SUBJECT: Transmittal of Revised Responses to AP1000 DSER Open Items

AP1000 Design Certification Review
Draft Safety Evaluation Report Open Item Non-Proprietary Responses

DSER Open Item Number: 19.1.10.1-5 (Response Revision 1)

Original RAI Number(s): 720.009, 720.012, 720.013, 720.014, 720.017, 720.021, 720.024, 720.025

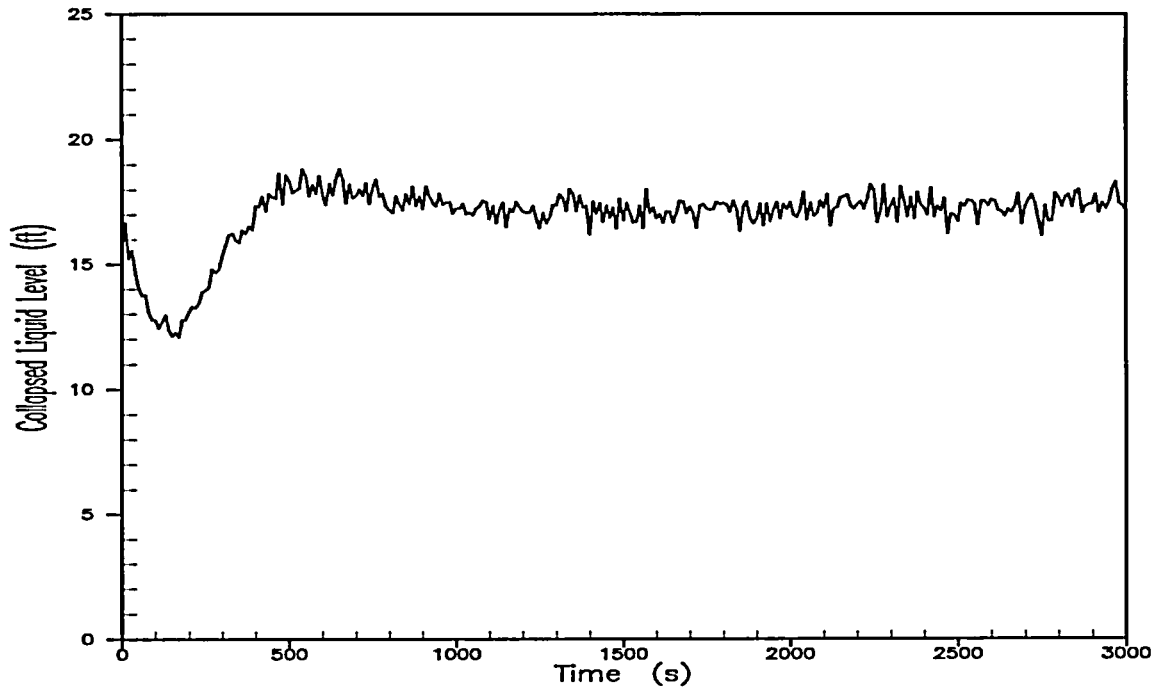
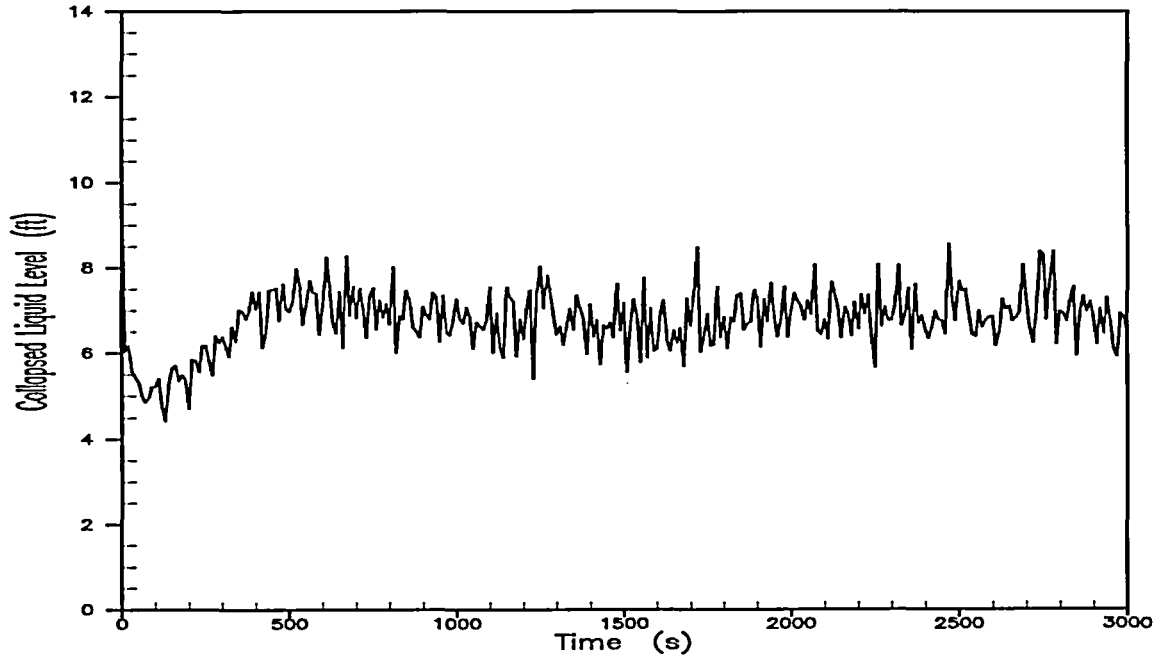
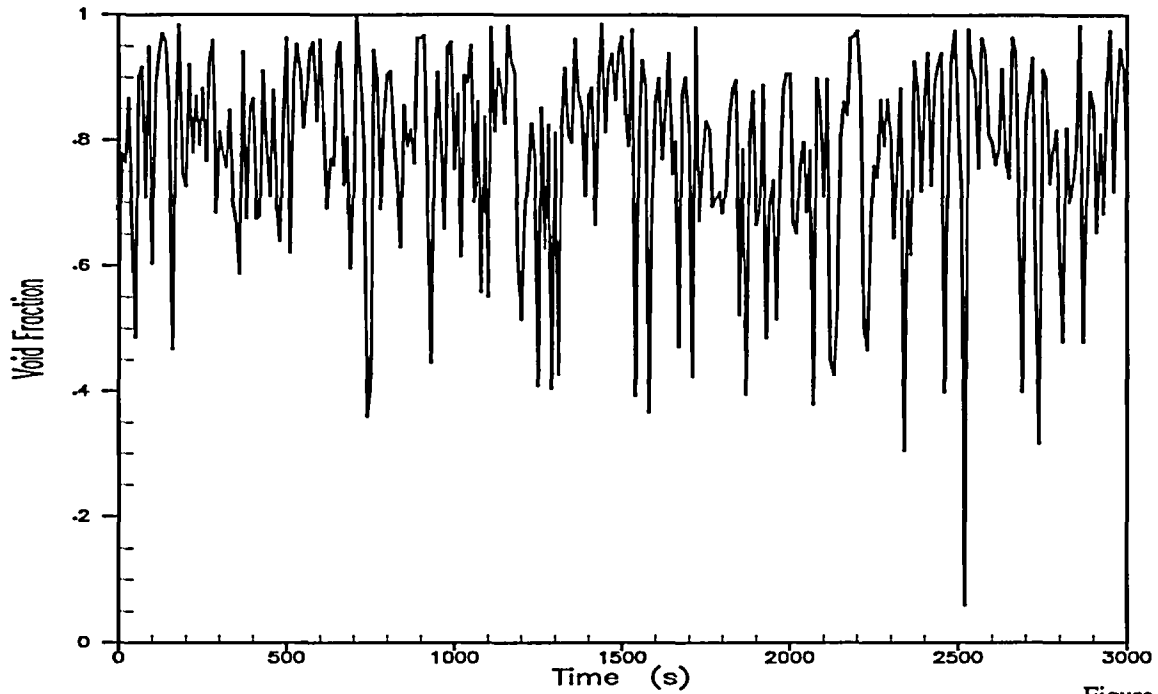
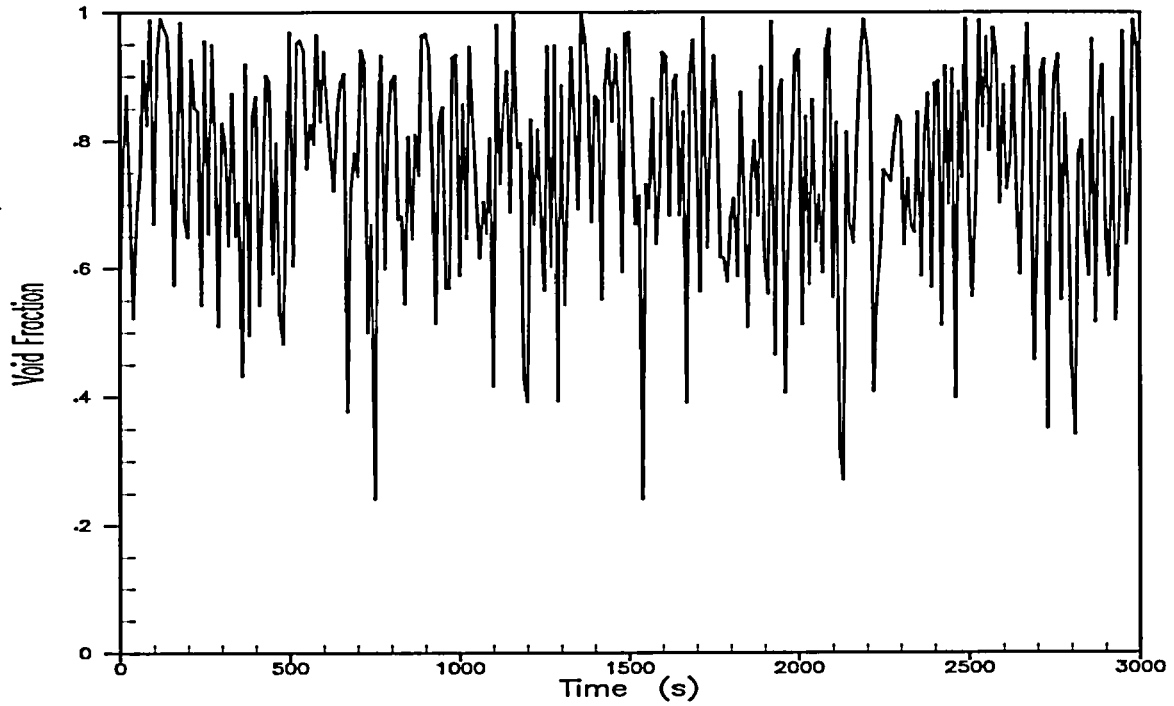
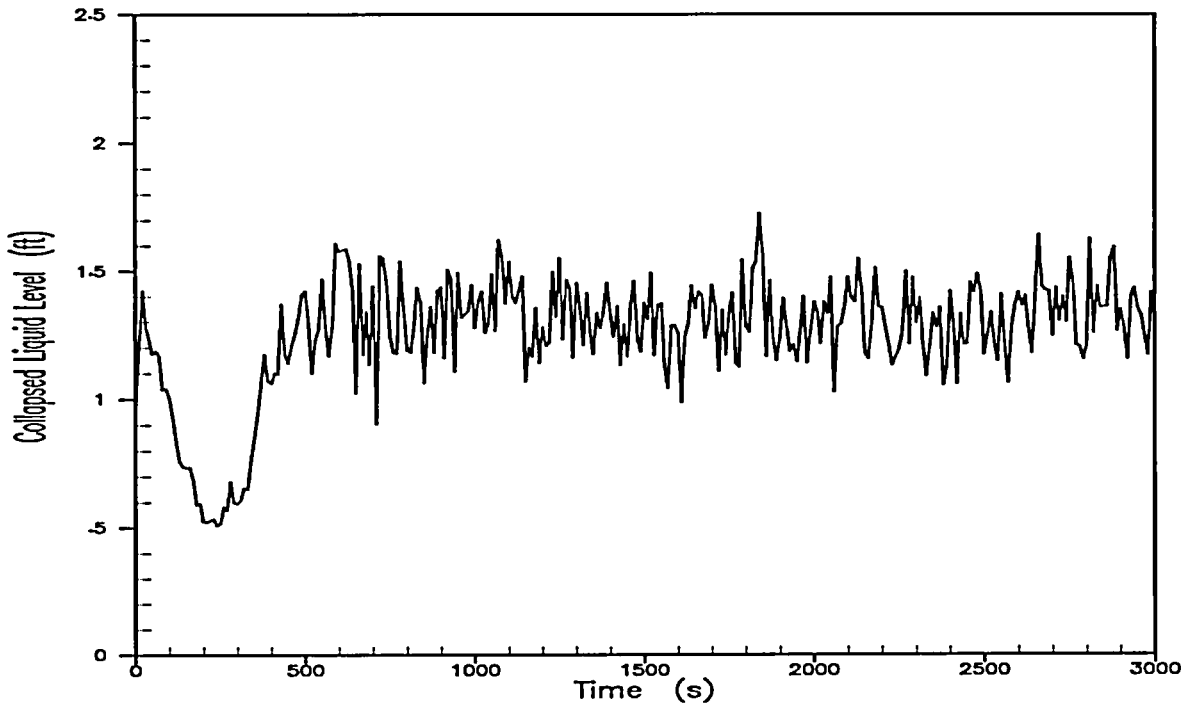
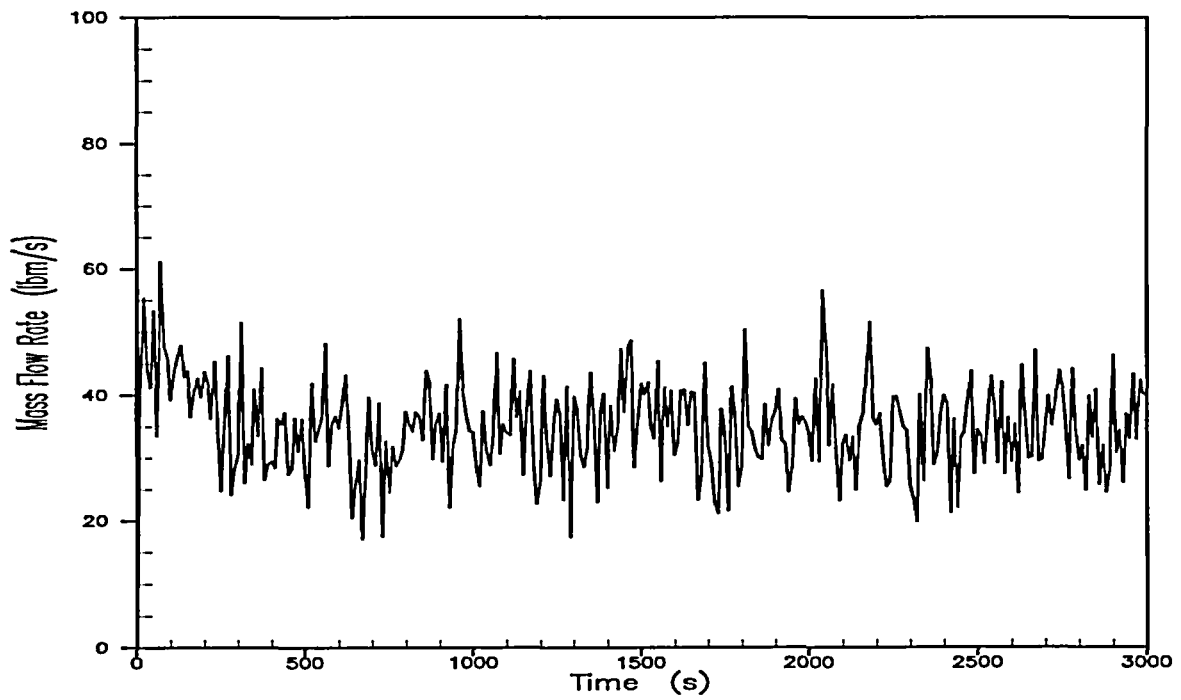
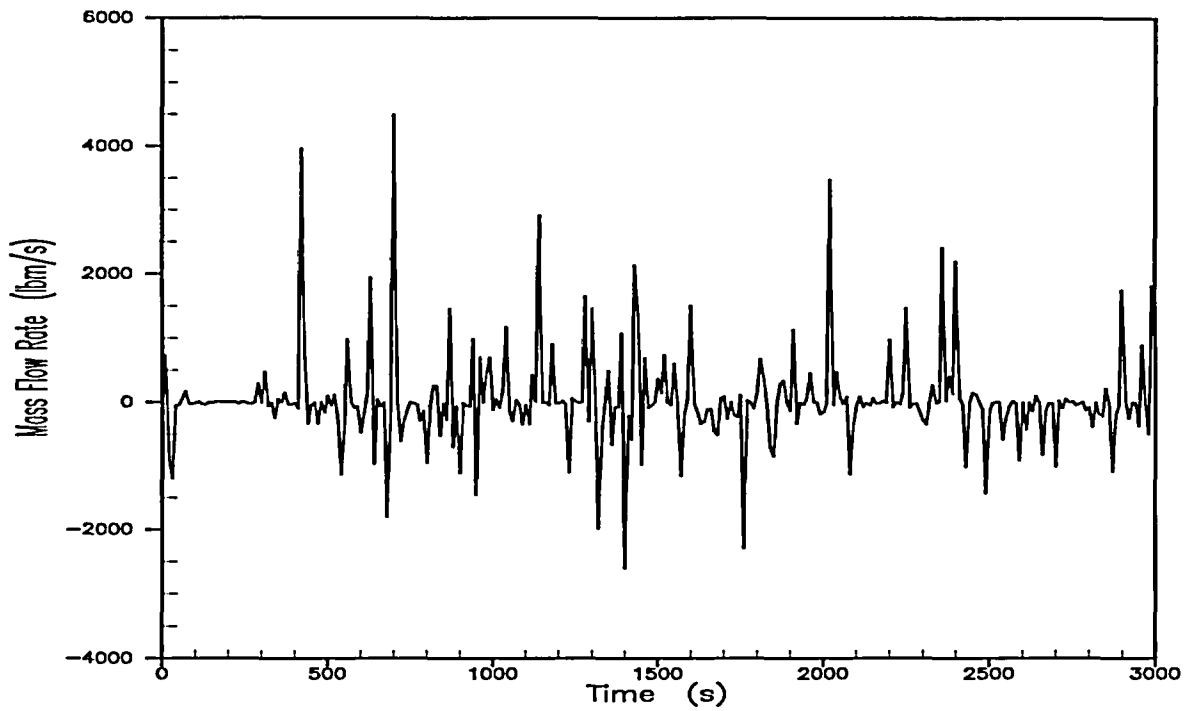
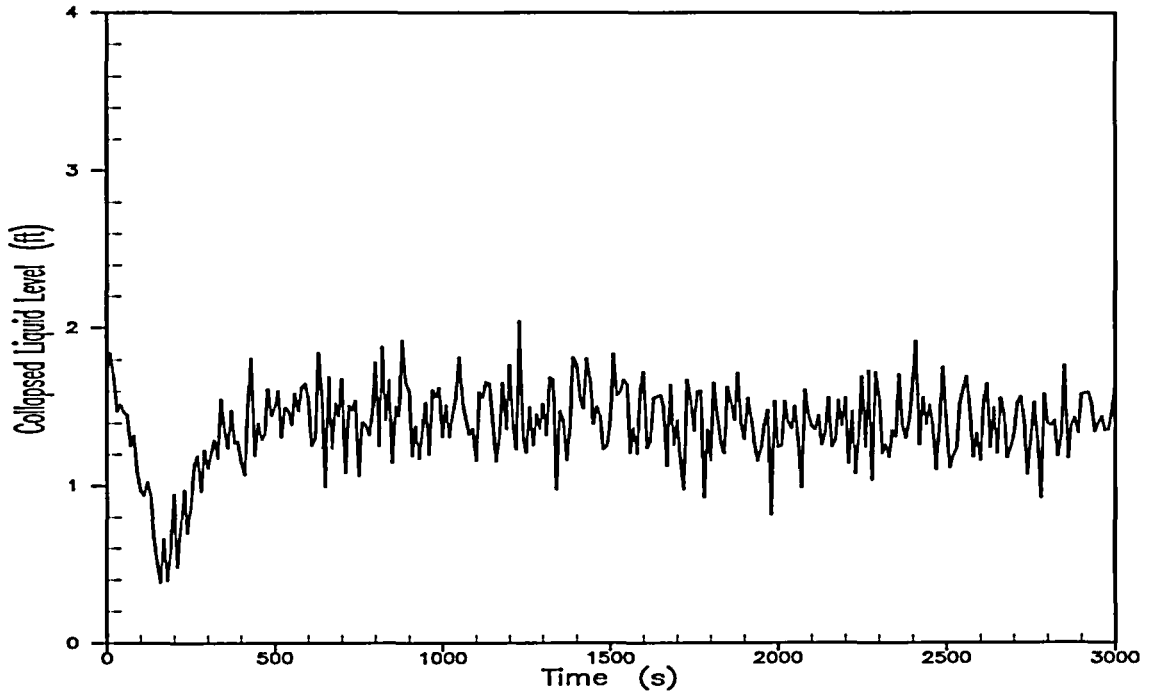
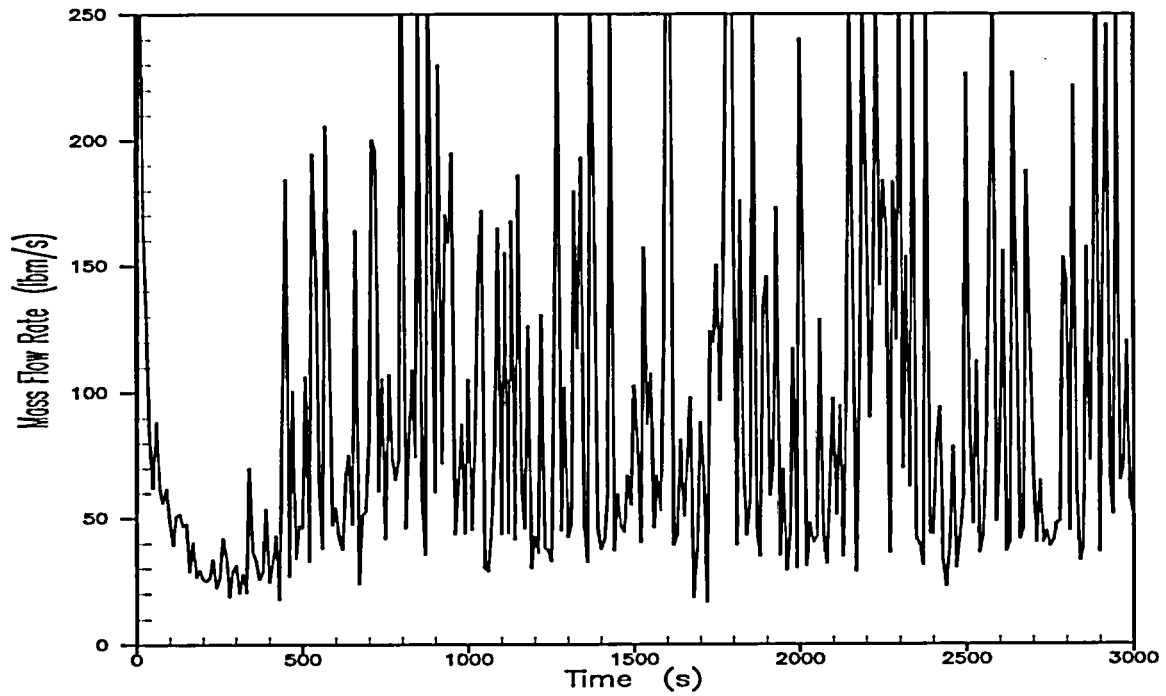
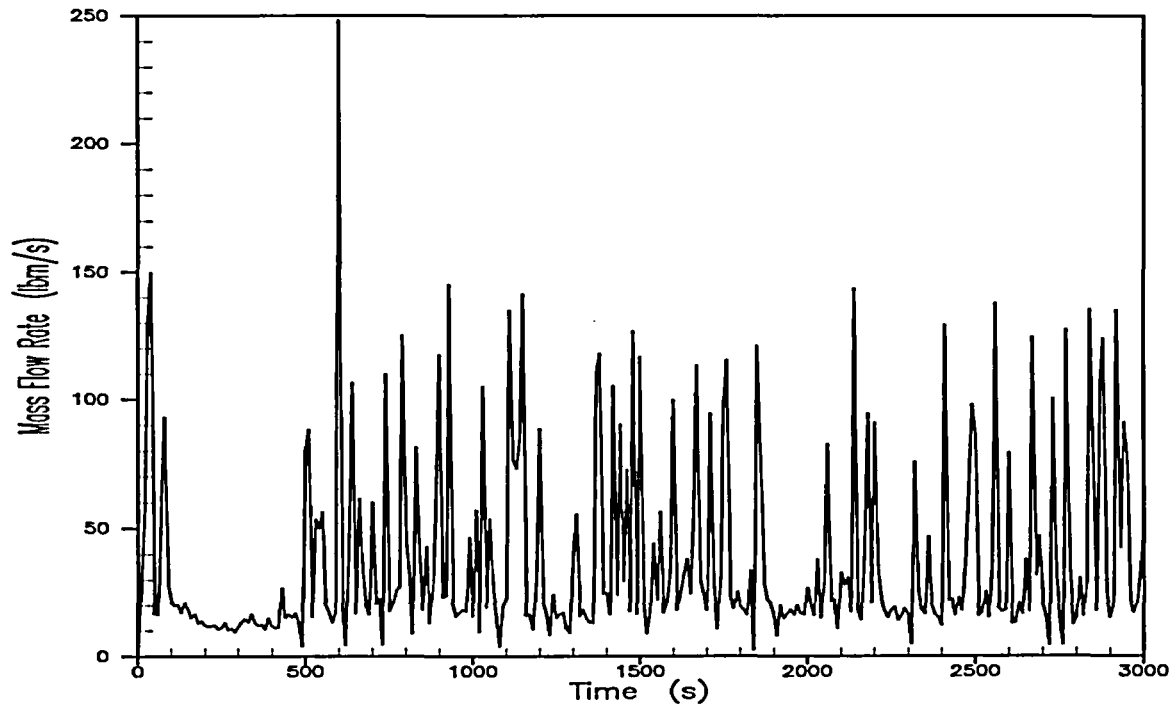
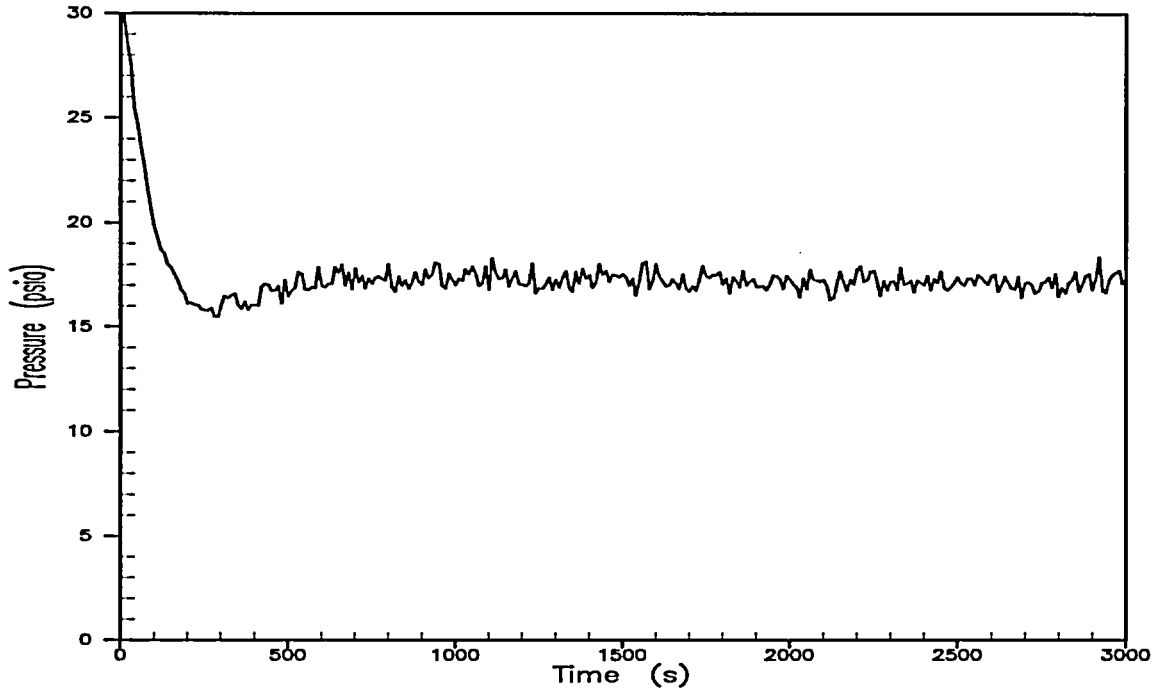
This issue is unresolved. In the revised response to RAI 720.09, Westinghouse presented the results of an analysis using WCOBRA/TRAC with inputs determined from a MAAP4 analysis. The staff has the same issue with this analysis as is stated under Item a. In the revised response to RAI 720.17, Westinghouse argued that this case is not risk significant and therefore it is not necessary to perform a T&H uncertainty analysis. This argument is not valid since OK6 (See Figure 2-4 of RAI 720.012), OK2 and OK4 sequences (on Figure 2-5 of RAI 720.012) fall in this category. Are these OK sequences considered to be low risk?

- (f) The long term cooling success criteria analysis in the revised response to RAI 720.09 (3 of 4 ADS4, containment isolation failure) has now been performed using the revised WCOBRA/TRAC model and using input conditions from WGOTHIC. The revised analysis replaces the previous one as shown below in the revision to PRA Appendix A. This confirms the success criteria for this case. With respect to the statement we made in RAI 720.017 rev 1 about a T&H uncertainty case with 3 ADS-4 valves and failure of containment isolation, we have the following response. Such a sequence is not risk important with the current expanded event trees. The question regarding sequences that we identified as OK sequences with 3 ADS-4 valves and CI failure is a new / different question. These sequences are less severe than the success criteria case in that they have some ADS 2/3 valves opening and have 1 CMT (in addition to 1 Accumulator). The addition of the CMT will compensate for the water lost out of the containment through a failed CI. In addition, these OK sequences have probabilities of ~ E-10 / yr, or less. The highest UC sequence with 3 ADS-4 and failed CI is UC8/sad27, see PRA Appendix A Table A5.1-2. This sequence has a CDF probability of 2 E-10 and is not risk important.

Initially, the only injection comes from the IRWST into the reactor vessel through the intact DVI injection line (Figure A3.5-14). At the beginning of the analysis, the liquid level in the PXS-B room is below the DVI injection nozzle elevation and steam from the downcomer is vented out through the break (Figure A3.5-13). Water starts to flow back into the downcomer through the broken DVI line during the transient when the liquid level in the PXS-B room becomes high enough to provide sufficient driving head. With the onset of this flow, additional water supplied

into the downcomer through the DVI break supplements the IRWST injection. As this flow path becomes established, the levels in the downcomer (Figure A3.5-1), the reactor core (Figure A3.5-2), and the upper plenum (Figure A3.5-8) are sufficient to maintain core cooling. The effect of this injection flow increase is also seen in Figures A3.5-3 and A3.5-4, which show a void fraction decrease in the upper half of the core.

The three available ADS Stage 4 valves provide enough venting capacity that adequate depressurization capability exists to achieve successful performance of the passive safety systems (Figures A3.5-9 and A3.5-10). The fuel remains covered throughout the transient, and adequate core cooling is provided to remove the decay heat. The hot rod cladding temperature at the top of the core is slightly above saturation temperature (Figure A3.5-12) throughout the transient.
